Subject: Objection (1) to DA2021/0668 - 95 Bower Street, Manly

Notification Response – Development Application DA2021/0668
Alterations and additions to the existing dwelling
No. 95 Bower Street, Manly

Development Application to Northern Beaches Council
95 Bower Street Manly

Objection to impacts on view sharing

VS04

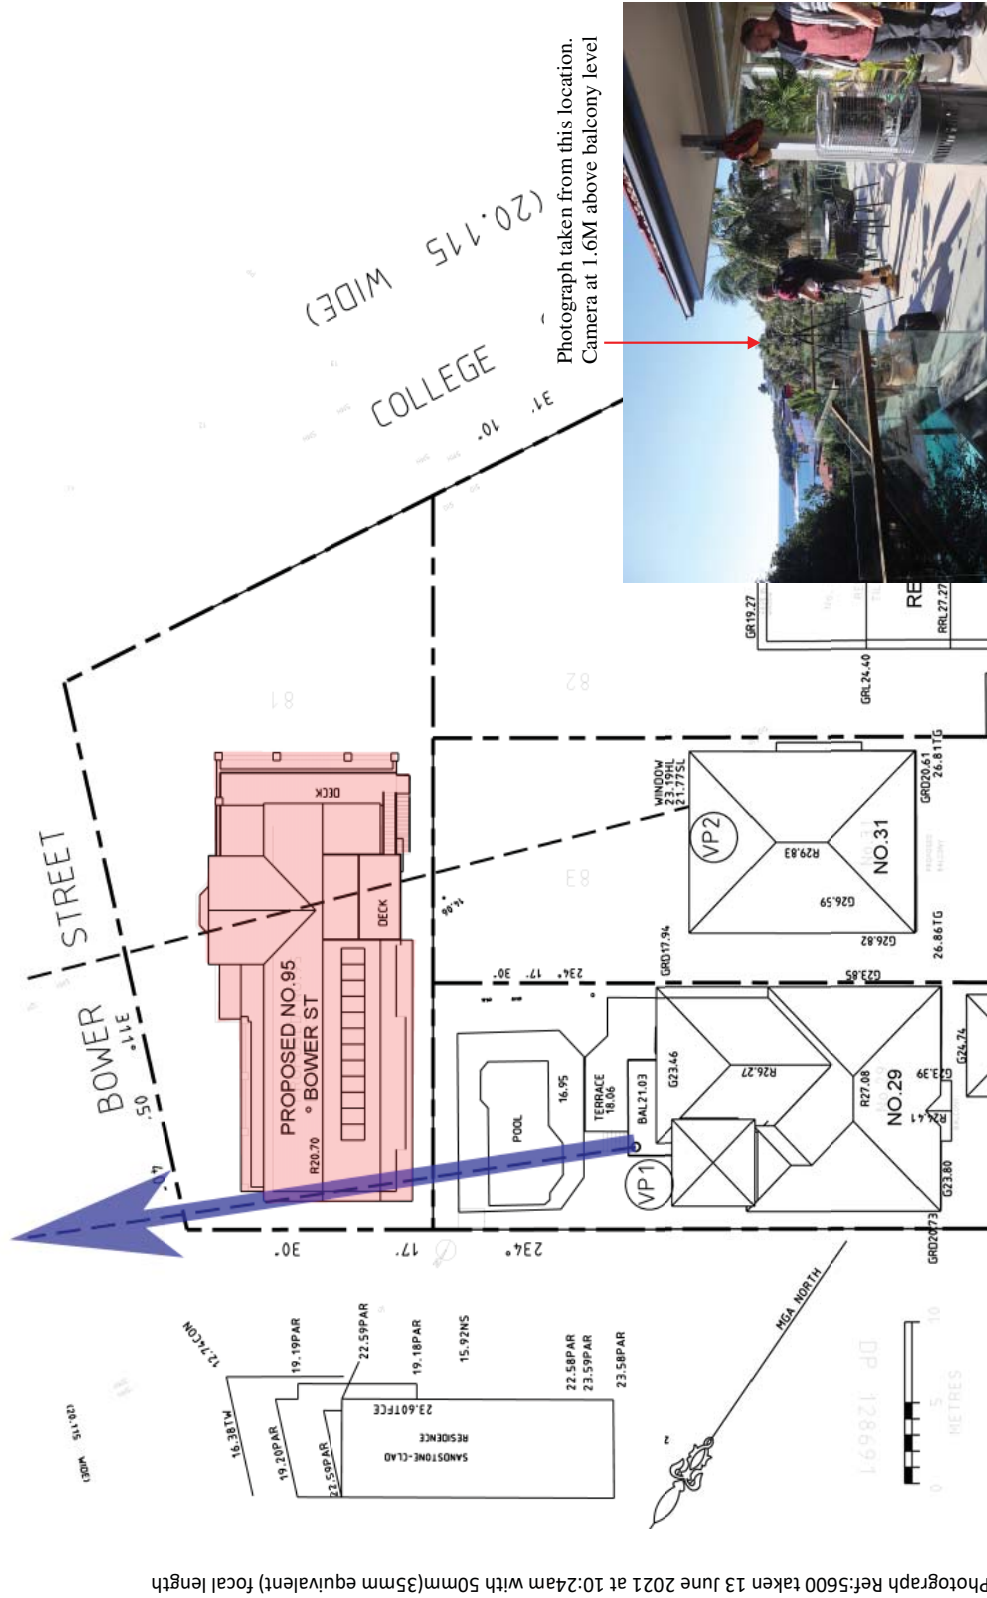
View loss caused by non-compliant area of proposed building which is above the height limit

In summary, the building as proposed will cause significant impacts on view sharing and is not reasonable. However it could easily be amended with either a flat or skillion roof, which could be supported on the grounds of view sharing.

Photograph with proposed No.95 Bower St as red outline
 View from No.29 Reddall St upper level balcony
 Objection to 95 Bower St, Manly

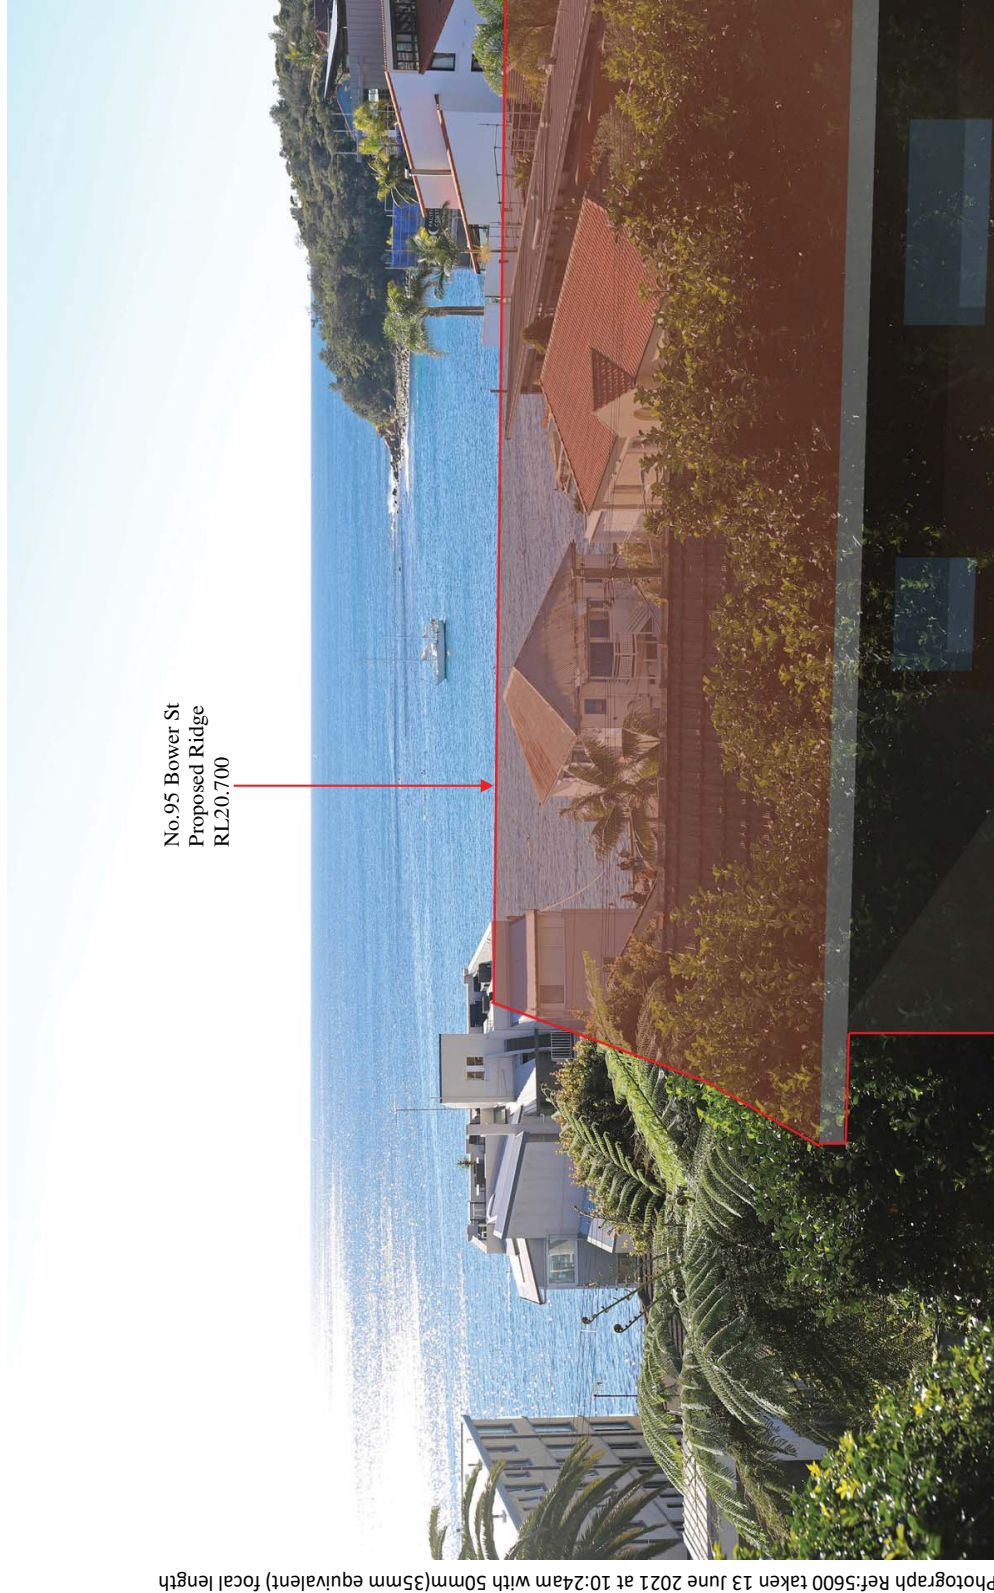
The impact on the view is moderate. A flat or skillion roof design would be reasonable

View Point 1 29 Reddall Street upper balcony showing flat roofed alternative design

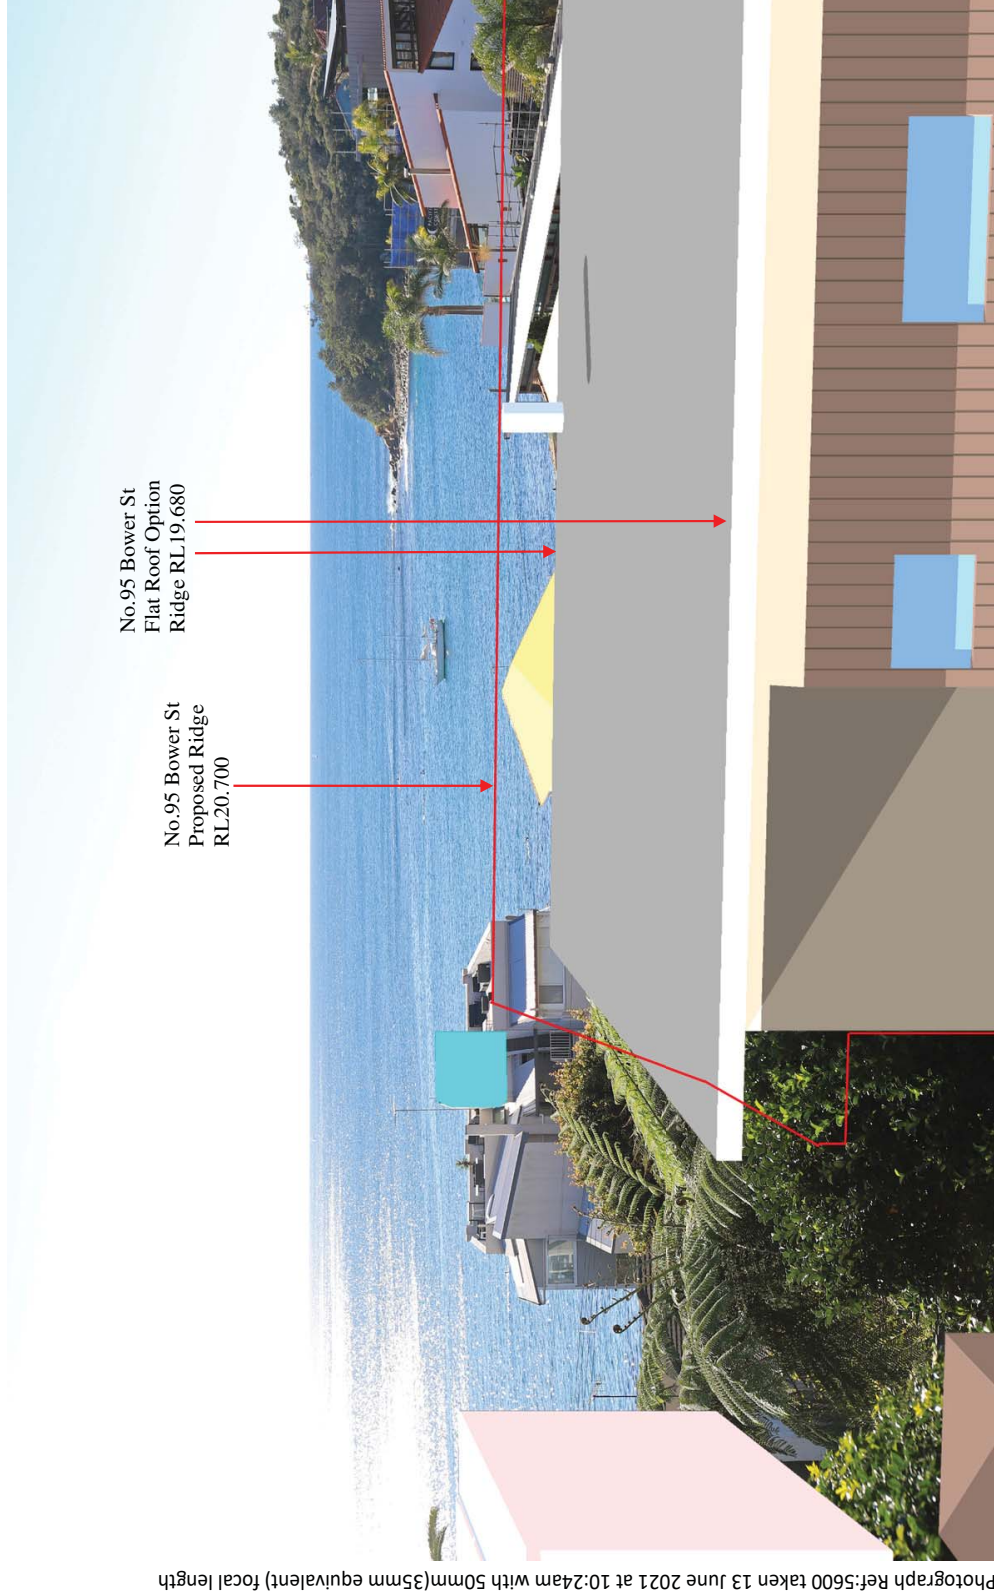
The impact on the view is moderate. A flat or skillion roof design would be reasonable

Photograph with proposed No.95 Bower St as red outline
 View from No.31 Reddall St middle level living area
 Objection to 95 Bower St, Manly

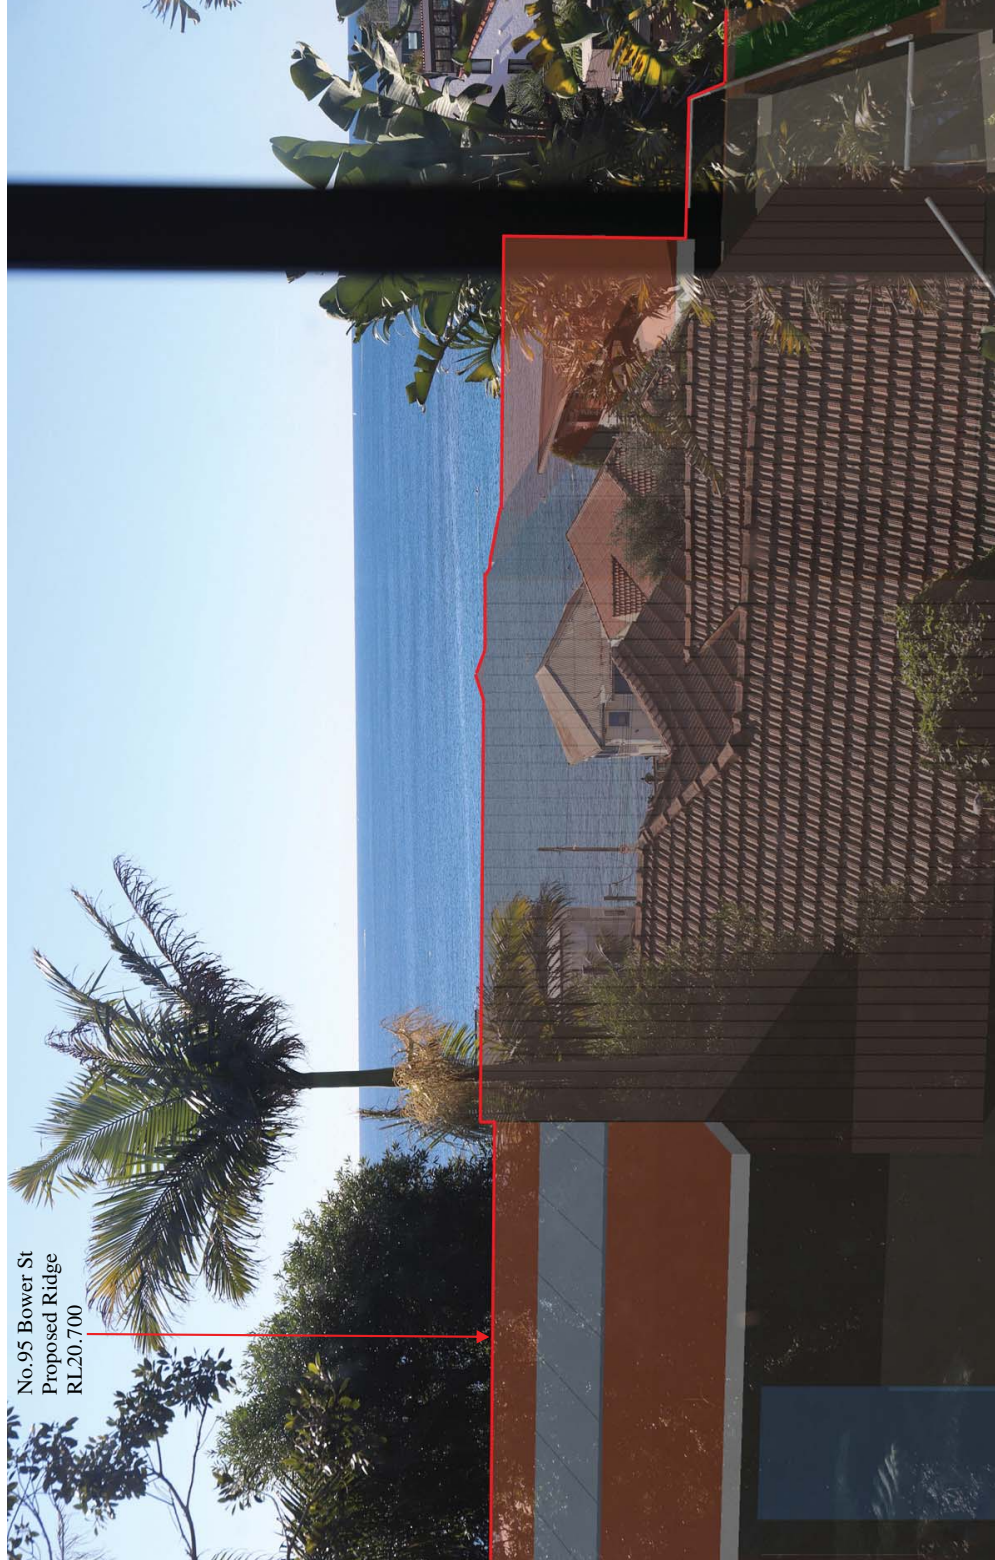
The impact on the view is moderate to severe. A flat of skillion roof would be reasonable

Photomontage with proposed No.95 Bower St as 50% transparency
View from No.31 Reddall St middle level living area
Objection to 95 Bower St, Manly

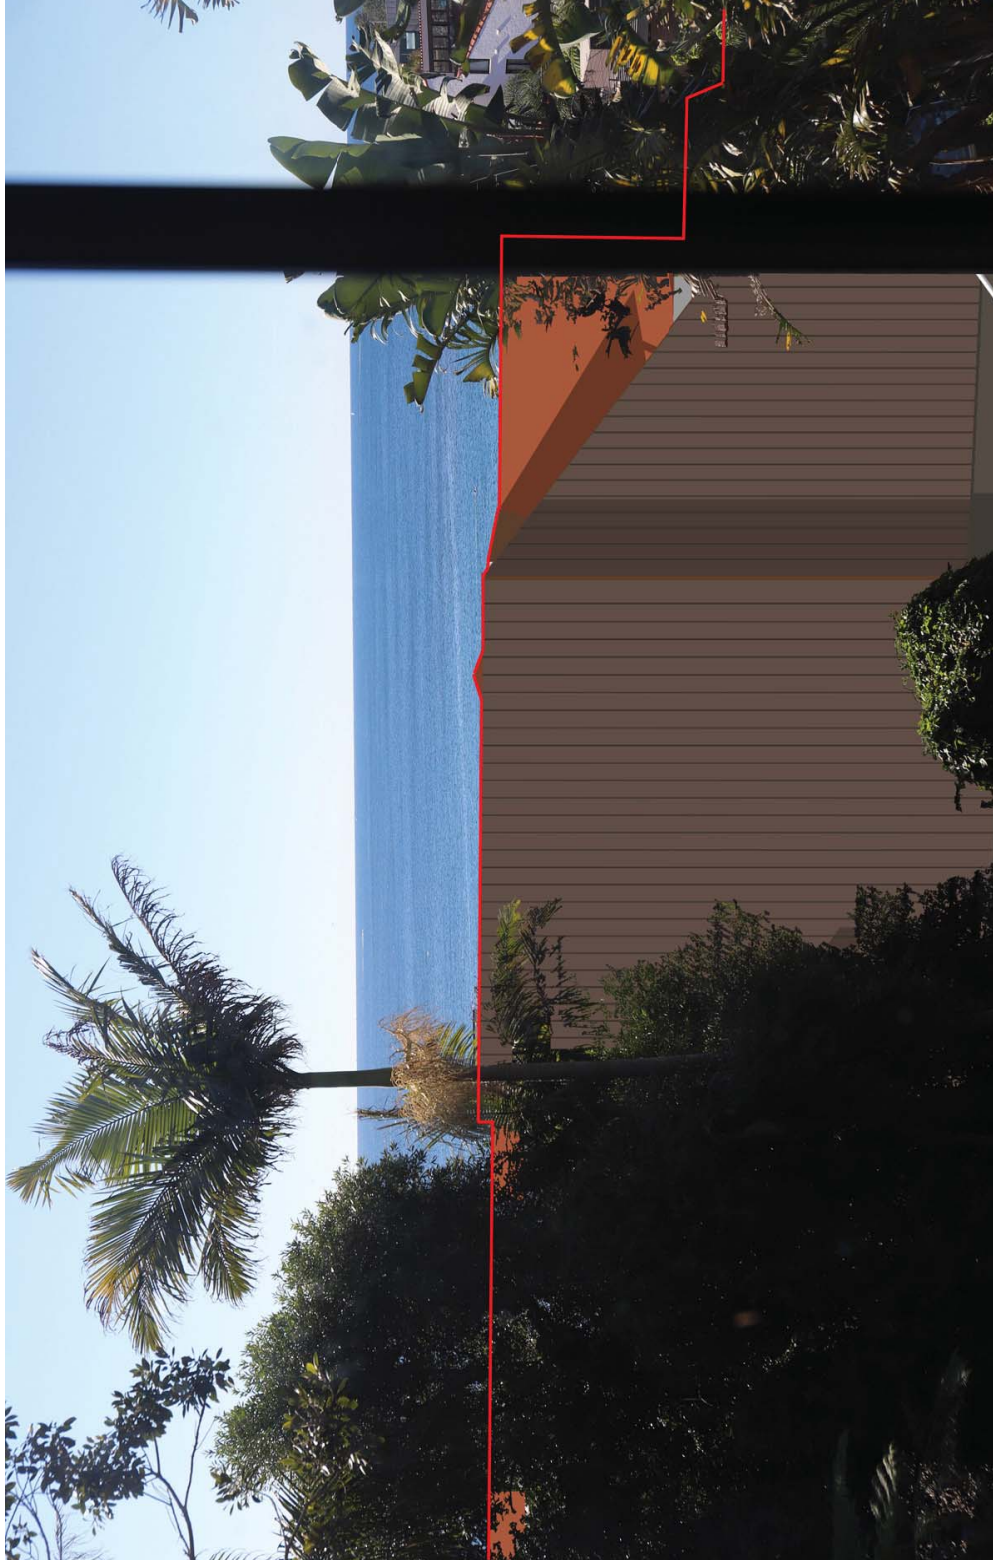
The impact on the view is moderate to severe. A flat or skillion roof would be reasonable

Photograph with 3D solid block model of proposed No.95 Bower St
View from No.31 Reddall St private open space area
Objection to 95 Bower St, Manly

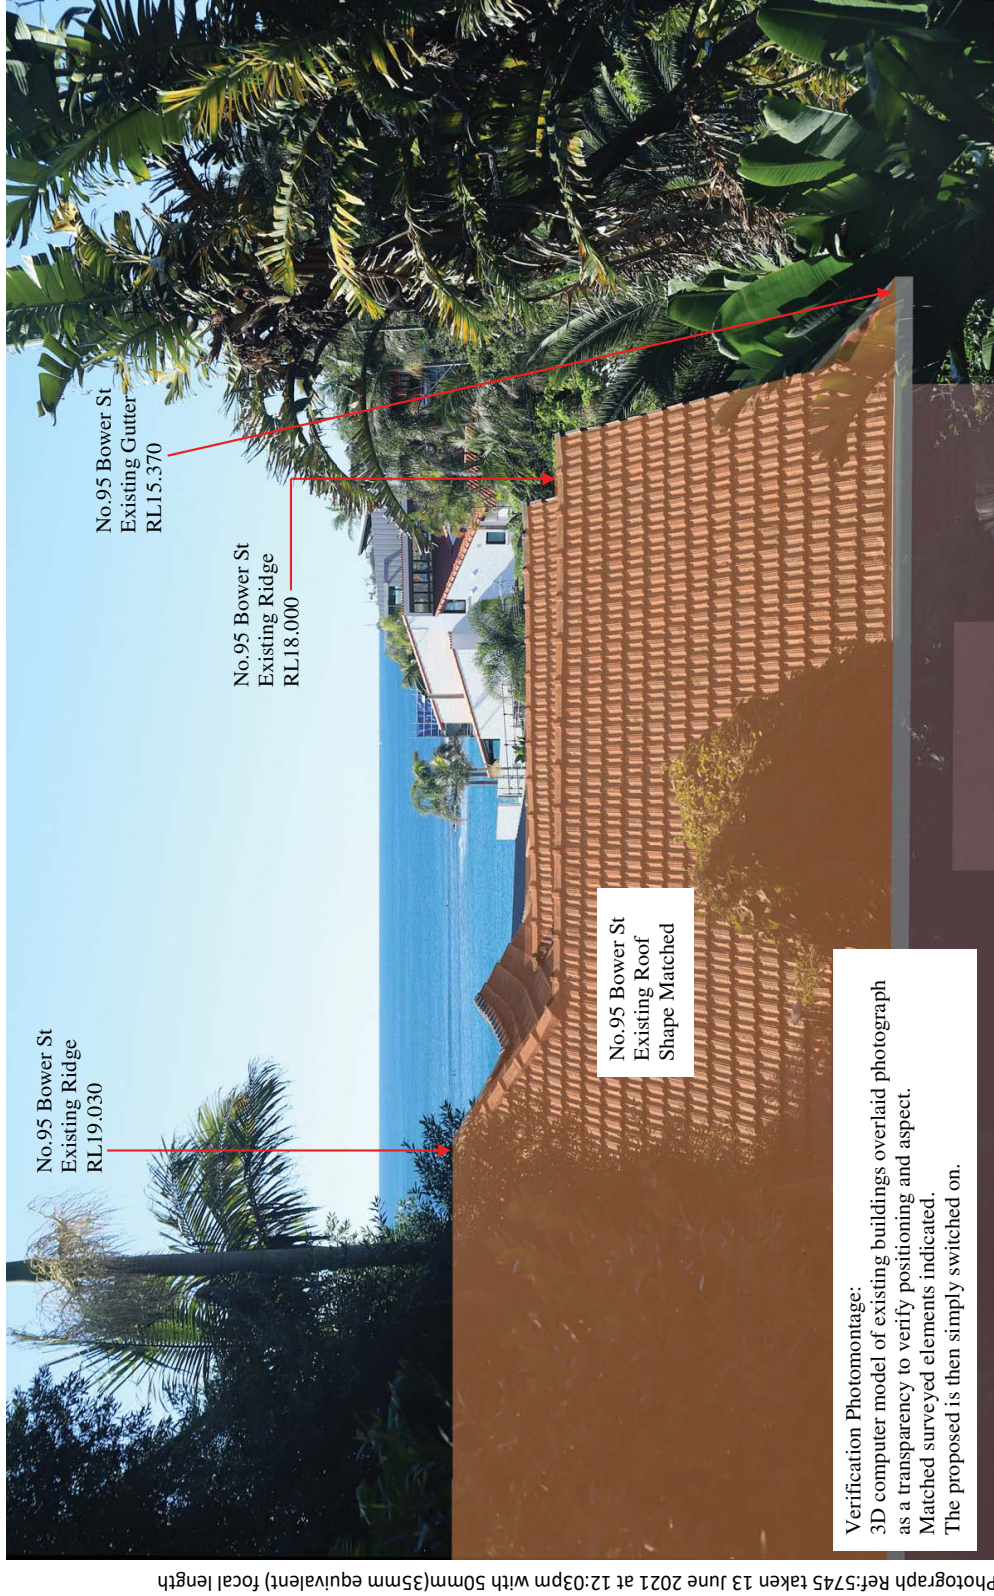
The impact on the view is devastating and exacerbated by the roof terrace privacy screen, which should be significantly lowered or removed
